Applicant(s)	:	Riffiee)	
)	
Serial No.	:	08/800,574)	Examiner:
)	Lee, R.
Filed	:	February 18, 1997)	
)	Art Unit:
Entitled	:	NARROWBAND VIDEO CODEC)	2613
)	
)

MARKED-UP COPY OF AMENDMENTS TO THE SPECIFICATION AND CLAIMS

FIGURE 1

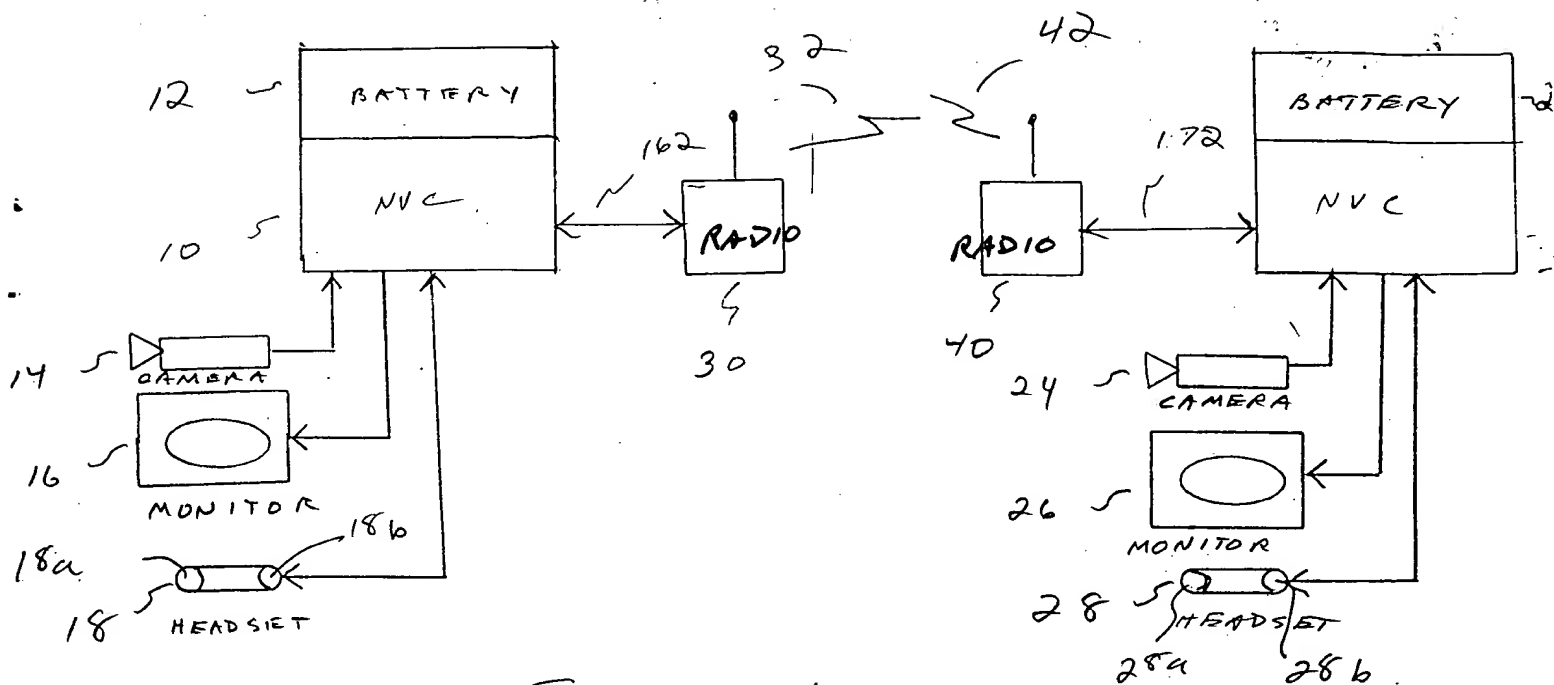
10 Responsive to the request by the Examiner to resubmit the proposed drawing changes that were submitted in response to the last Office Action, Applicant has submitted herewith a proposed Request for Drawing Change. More particularly, Figs. 1, 2 and 3C have been revised to label the diagrammatic blocks 30 and 40 of Fig. 1, blocks 14, 16, 18, 120 and 200 of Fig. 2, and block 120 of Fig. 3C so as to indicate the contents and/or function thereof, as requested by
